# Core objections to planning scheme 2023/2245/P

redevelopment of the office block at 160-161 Drury Lane London WC2B 5PN.

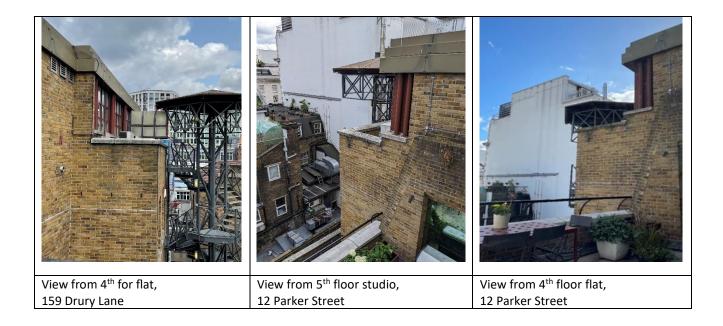
We also strongly object to the fifth floor back extension.

The additional extension will introduce additional bulk and mass to an already substantial building. It would have an adverse overbearing effect that would result in an unduly oppressive living environment for existing residents within Flat 6, 12 Parker Street and residential properties in Drury Lane as shown in the photographs below. It will create a sense of enclosure and adversely affect the outlook from habitable room windows.

This 5<sup>th</sup> floor element should be deleted from the application.

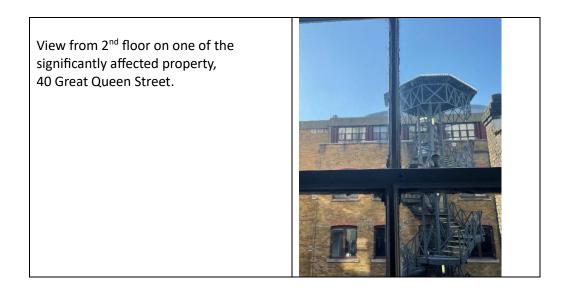
Residents' objection to this terrace revolves around privacy and noise; The proposed terrace would be one storey higher than the view in the photograph below and will allow direct views into habitable windows in Parker Street, Drury Lane and Parker Street, resulting in a material loss of privacy.

Any screening (none is proposed in the drawings) to overcome loss of privacy will add further bulk and height resulting in even further detriment to daylight/ sunlight and outlook from these habitable room windows.

With the emergence staircase removed the terrace will be of a sufficiently large size to accommodate a sizeable number of people and given the office usage it is assumed that it will be used for entertainment. The terrace will be in close proximity to habitable windows serving residential properties along Drury Lane, Parker Street and Great Queen Street and would create significant noise and disturbance from conversation and music which would be detrimental to the amenities of these residents.

This Council should maintain its 2019 stance that the use of any rear terrace (and the flat roof on top of the main building) should be for emergency use only.
